# Hillsborough County Florida

## STAFF REPORT

<b>SUBJECT:</b>	PRS 20-1312	<b>PLANNING AREA:</b>	Greater Carrollwood Northdale
<b>REQUEST:</b>	Minor Modification to an Approved PD	<b>SECTOR:</b>	Northwest
<b>APPLICANT:</b>	Surya Estates, LLC		
<b>Existing Zoning:</b> PD 84-0084		<b>Comp Plan Category:</b> RES-4

**Exhibit 3:** Proposed 3-Lot Configuration

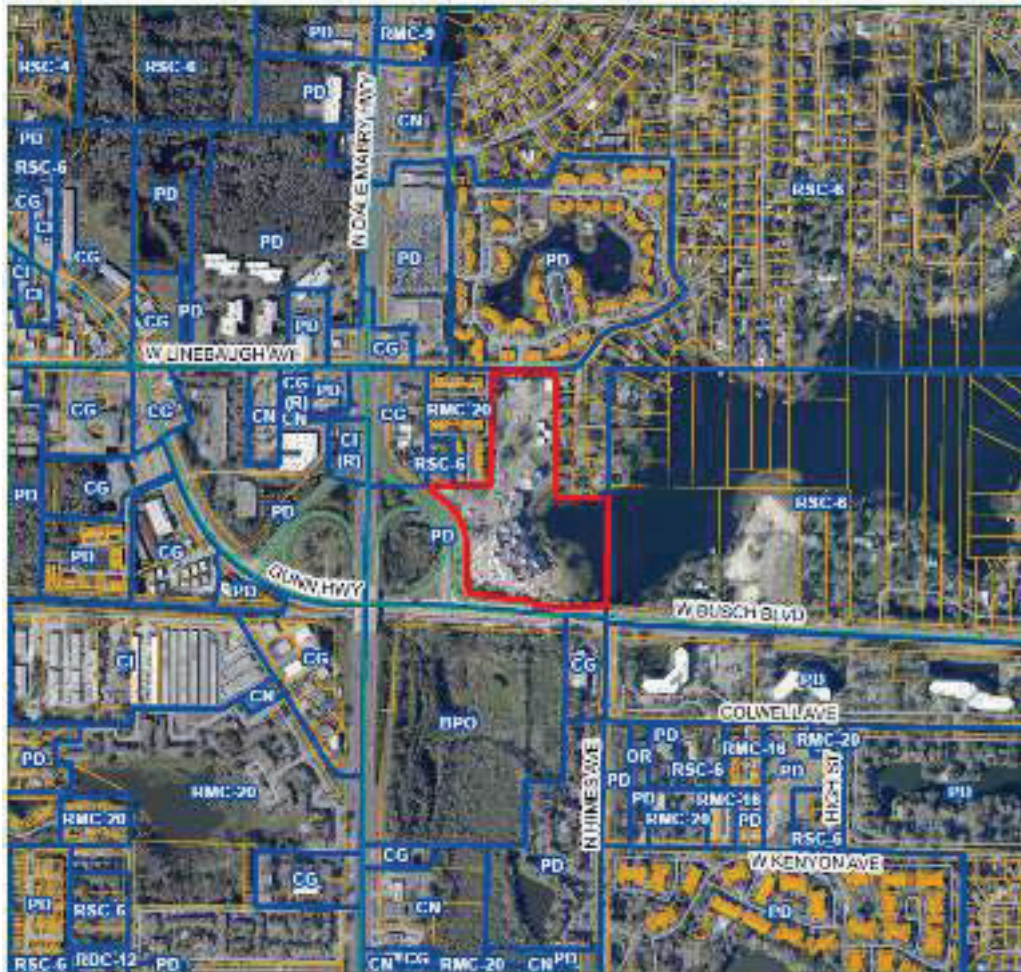
The request is to modify the conditions of approval to fit the subdivision of the parcel into three (3) individual lots consisting of the primary residence and two secondary residences on the premises. The remainder of the structures consisting of 3 guest homes and a caretaker's home will be located on one common tract and managed by the home owner's association.

The modifications to the approved final zoning conditions are needed because the three primary structures on the premises were conforming to the RSC-6 setback requirements as a one parcel project. However, with the introduction of 3 separate lots, the existing structure are closer than the required 7.5 foot side yard setback for the RSC-6 standards. The applicant seeks to reduce the minimum required side yard setback of 7.5 feet by 4.5 feet to allow the side yard to be a minimum of 3 feet for all three lots.

The applicant is also seeing a 25-foot reduction to the required front setback for the primary residence (lot 1) resulting in a setback of 0 feet from the west lot line.

1. KEY SHEET
2. PROP. MINOR PD MODIFICATION PLAN

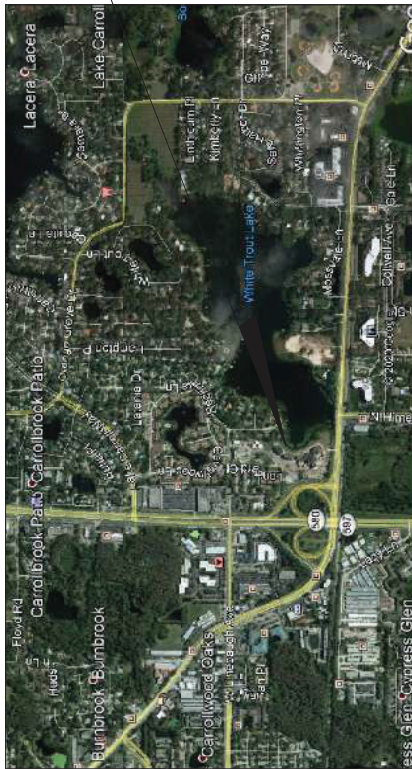
Approval of the request, subject to the conditions listed below is based on the general site plan submitted July ~~12, 2012~~, December 23, 2020

- 2.1 The minimum front yard setback for lot 1 shall be zero (0) feet.
  - 2.2 The minimum side yard setback for lots 1,2 and 3 shall be three (3) feet.
